SIB 11 01 20

REPLACING TIMING CHAIN REAR GUIDE AXLE

2020-05-20

E-Series	Model Description
K67 (0E23)	S 1000 RR
K69 (0E41)	S 1000 XR

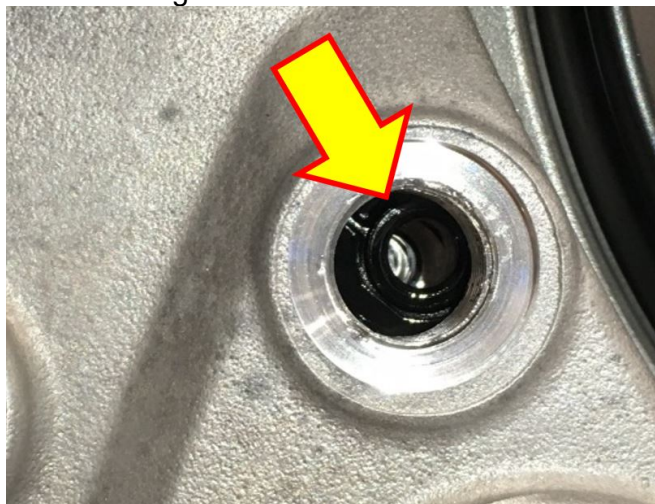
BMW Motorrad has ascertained that the engine installed in the affected vehicles may have a burr present in the guide bore for the oil supply of the timing chain. The burr can dislodge over time due to vibrations and oil pressure fluctuations (incl. temperature influences). This can cause a narrowing or restriction of an oil duct or oil spray nozzle. A lack of lubrication (e.g. the timing chain) or insufficient cooling (e.g. the piston) can be the result.

In the vehicles concerned, the timing chain rear guide axle (aka pivot bolt; circled) - when viewed in the direction of travel – must be replaced.

Note: The front chain guide axle (pivot bolt) is not affected. Only the rear one involves the oil circuit.

The chain guide axle can be replaced without additional preparatory work. A new gasket ring must be used when installing the new axle.

In addition, care must be taken to first insert the axle into the chain guide and then align the axis in the middle of the screw hole (arrow) so that it is not installed at an angle.

The tightening torque for the new axle is 30 Nm.
